28 November 2014

James Mah-Chut
Dexus
Level 25, Australia Square
264-278 George Street
Sydney NSW 2000

**DISCUSSION PAPER
SEPP 65 UPDATE AND APARTMENT DESIGN GUIDE -
APPLICATION TO RESIDENTIAL TOWER DEVELOPMENT**

Diagram showing possible tower relationships

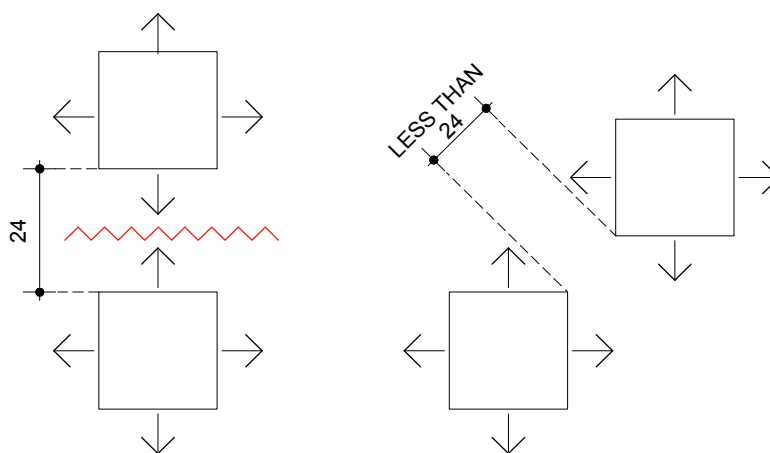
- The possibility of reduced building separation between buildings through careful siting inter-relationships should be further explored, and specifically in relation to freestanding towers. . Again, the ADG diagrams demonstrate that the focus of the controls and performance criteria is weighted towards lower height urban typologies. Off-set towers can be located closer than 24 metres, whilst maximising views for residents and at the same time improving visual cross privacy to a greater degree than adjacent or opposite towers.

In tight and dense inner city centres achieving this may be more difficult to achieve, however the principle of resolving visual privacy through design is an important concept that could be demonstrated in the ADG.
